UNITED STATES PATENT AND TRADEMARK OFFICE

Office Action Summary	Application No. 10/528,920	Applicant(s) SMITH ET AL.
	Examiner Melody M. Burch	Art Unit 3657

DETAILED ACTION

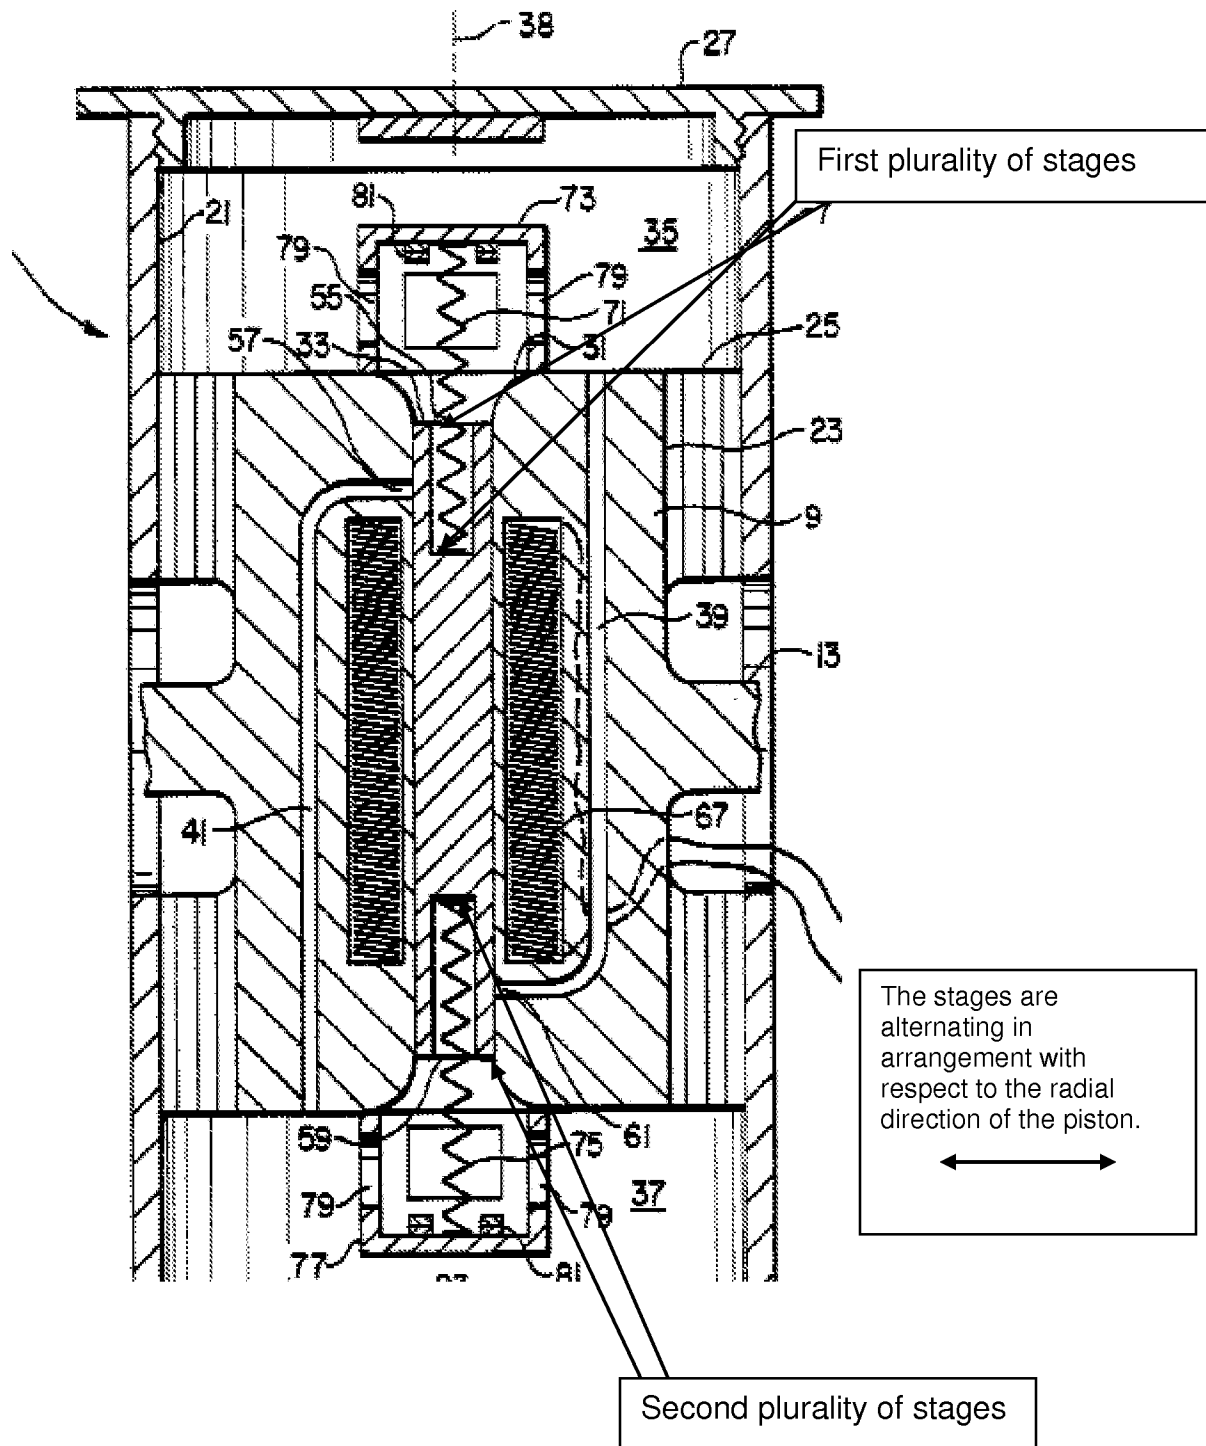
Re: claim 21. McKeown et al. show in figure 4 a vibration isolator comprising a housing 7,27,29, a piston 33 resiliently disposed within housing, the piston being adapted for connection to a first body, a first fluid chamber 35 and a second fluid chamber 37 each being defined by the housing and the first piston, a first tuning port or top of 31, 41 in fluid communication with both the first fluid chamber and the second fluid chamber; and a tuning fluid disposed within the first fluid chamber, the second fluid

chamber, the first tuning port, and the second tuning port; wherein the first tuning port allows isolation of vibration at a first selected frequency, the isolation of vibration at the first selected frequency being a result of displacement of the tuning fluid in the first tuning port, the displacement being a result of movement of the piston, wherein the second tuning port allows isolation of vibration at a second selected frequency, the isolation of vibration at the second selected frequency being a result of displacement of the tuning fluid in the second tuning port, the displacement being a result of movement of the piston.

McKeown et al. are silent with regards to the vibrations being harmonic.

Re: claim 23. McKeown et al., as modified, teach in figure 4 of McKeown et al. a spring-mass system 75, 77 associated with the second tuning port, the spring-mass system being configured to provide an additional degree of freedom.

Re: claim 24. McKeown et al., as modified, teach in figure 4 of McKeown et al. additional tuning ports top 79 and bottom 79 wherein each additional tuning port allows isolation of vibration at a corresponding additional selected frequency.

Re: claims 25 and 27. McKeown et al. show in figure 4 a vibration isolator comprising: a first housing 7, 27, 29 a first piston 9 resiliently disposed within the first housing, the first being adapted for connection to a first body, a tuning port 31,41 in fluid communication with both a first fluid chamber 35 and a second fluid chamber 37, the first fluid chamber and the second fluid chamber each being defined by the first housing and the first piston as shown, a second housing 73, a second multi-stage piston 33 resiliently disposed within the second housing, the second piston being configured to define a first plurality of stages in fluid communication with the first fluid chamber and a second plurality of stages in fluid communication with the second fluid chamber; at least one actuator 67 coupled to the second multistage piston 33 for selectively transferring forces to the second multistage piston; a tuning fluid disposed within the first fluid chamber, the second fluid chamber, the tuning port, the first plurality of stages, and the second plurality of stages.

Re: claim 28. McKeown et al. show in figure 4 a first housing 73, a first multistage piston 33 resiliently disposed within the first housing, the first multistage piston being configured to define a first plurality of stages in fluid communication with a first fluid chamber 35, and a second plurality of stages in fluid communication with a second fluid chamber 37; a second housing 7, 27, 29; a second piston 9 resiliently disposed within the second housing, the second piston being adapted for connection to a first body; at least one actuator 67 coupled to the first multistage piston 33 for

With regards to claims 21, 23, and 24, Applicant argues that the McKeown reference, as modified, fails to read on the limitations added to amended claim 21. Examiner disagrees and notes that the movement of the piston within the first tuning port or top portion of 31 and 41 and the second tuning port or bottom portion of 31 and 39 of McKeown, as modified, results in the isolation of harmonic vibrations at various frequencies.

With respect to claims 25 and 27 Applicant argues that McKeown does not anticipate the claims because McKeown does not have a second housing. Examiner disagrees and notes that element 73 is a second housing which houses the second piston 33, particularly in its extended position when it contacts buffers 81. Applicant

also argues that McKeown fails to show or suggest the limitation of the at least one actuator coupled to the second piston explaining that element 67 is not coupled to element 33. Examiner disagrees and notes that, as broadly recited, the at least one actuator 67 is magnetically coupled to piston 33. This response also applies to the similar arguments presented with respect to claim 28.
